Dale Bracewell, Manager of Transportation Planning, City of Vancouver

Re: Recent Improvements to King Edward Avenue Cycling Infrastructure

**Figure 19 - King Edward eastbound after MacDonald**

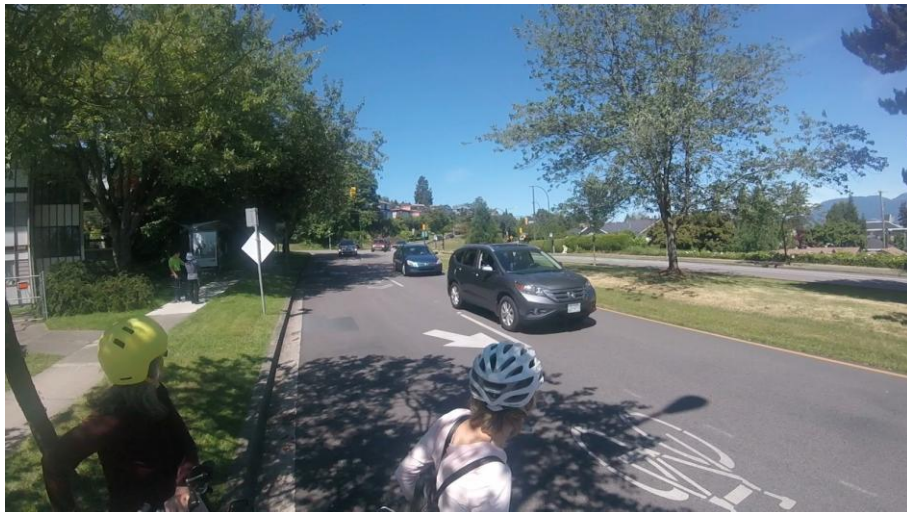
Immediately after MacDonald, there is a transit stop, with the curb lane having sharrows. This continues until the painted bike lane and parking resume after the transit stop, as shown in Figures 19 and 20. This creates a danger zone as there are vehicles carrying through the intersection in the curb lane, and vehicles turning right off MacDonald northbound onto King Edward, as well as buses, all competing for space with people on bicycles.
